To: **Planning Services
Lake District National Park Authority
Murley Moss
Oxenholme Road
KENDAL
LA9 7RL**

OBJECTION TO PLANNING APPLICATION 7/2018/3088
INSERTION OF MULTIPLATE ARCH UNDER BRIDGE 87 AT HILL COTTAGES

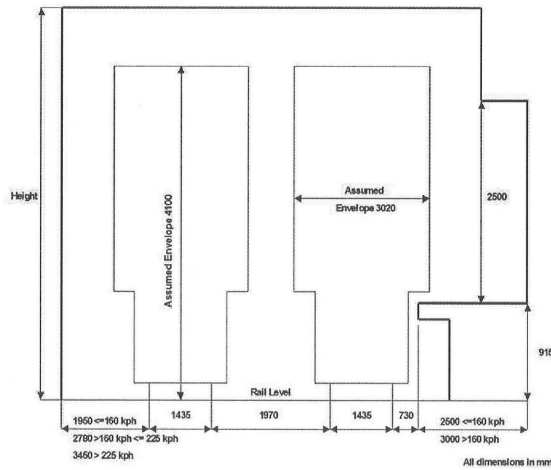
The work actually needed is to replace the bridge deck which has become weak. For a structure of such age, designed for lighter traffic replacement now should not be unexpected.

The Applicant has not demonstrated that the proposed method is the most cost effective or has more long term benefits than simply replacing the deck with a modern fabricated items designed to carry modern road vehicles.

CKP Railways plc believes that the method proposed would require more work on site, and be more disruptive to neighbours but not guarantee the long term future of the bridge.

CLEARANCES REQUIRED BY RAILWAY GROUP STANDARD GE GN 8573

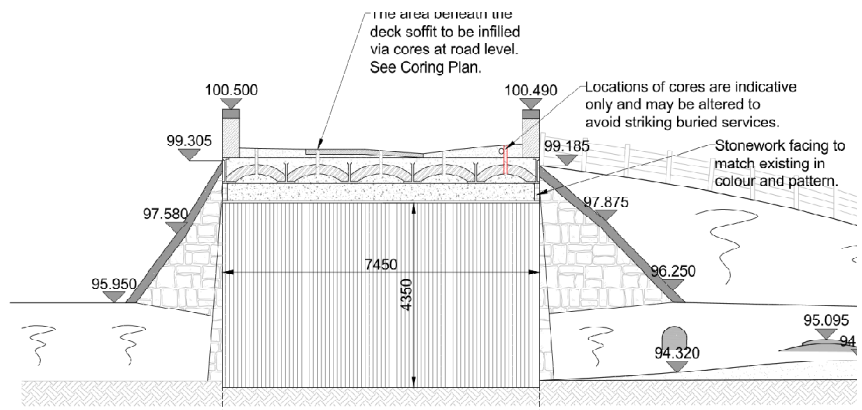
The diagrams below indicate the clearance required by the current Railway Group Standards applicable to modern main line railways to carry passenger and freight trains, against the clearances which the Applicants' work would provide.

Clearly it will be impossible to operate modern trains through the bridge as modified by the Applicants' proposed work.

Modern trains require a clear height of more than 5 metres below a bridge deck with a flat top profile (rectangular space) to allow for train + track + ballast above formation level.

Clear width required for double track through structures minimum 7.2 metres (vertical wall).
Clear width required for double track through structures minimum 3.8 metres (vertical wall).
